# UNITED STATES PATENT AND TRADEMARK OFFICE

APPLICATION NO.	FILING DATE	FIRST NAMED INVENTOR	ATTORNEY DOCKET NO.	CONFIRMATION NO.
10/609,438	07/01/2003	Je-Chang Jeong	Q75265	7906

## Office Action Summary

FIGURE 4

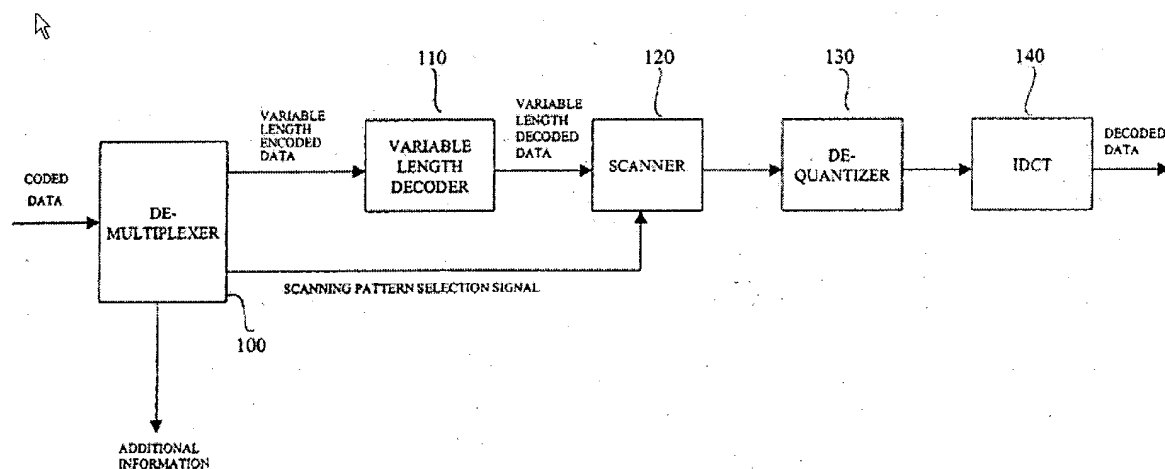
3. The amendment filed July 1, 2003 is objected to under 35 U.S.C. 132 because it introduces new matter into the disclosure. 35 U.S.C. 132 states that no amendment shall introduce new matter into the disclosure of the invention. The added material which is not supported by the original disclosure is as follows:

**In the drawings:**

The addition of new figure 4 is shown below:

Applicant is required to cancel the new matter in the reply to this Office Action.

The original disclosure fails to remotely support any written description of a decoder as now claimed. Details of the decoder, as now claimed, only can be gleaned from the new matter that is now provided by the Preliminary Amendment filed July 1, 2003. Applicants' remarks in the Preliminary Amendment indicate that new claims submitted are fully supported by the original specification by at least col. 2, line 52 – col. 3, line 38. However, the examiner fails to ascertain details of a decoder in these cited columns as alleged by the applicants.
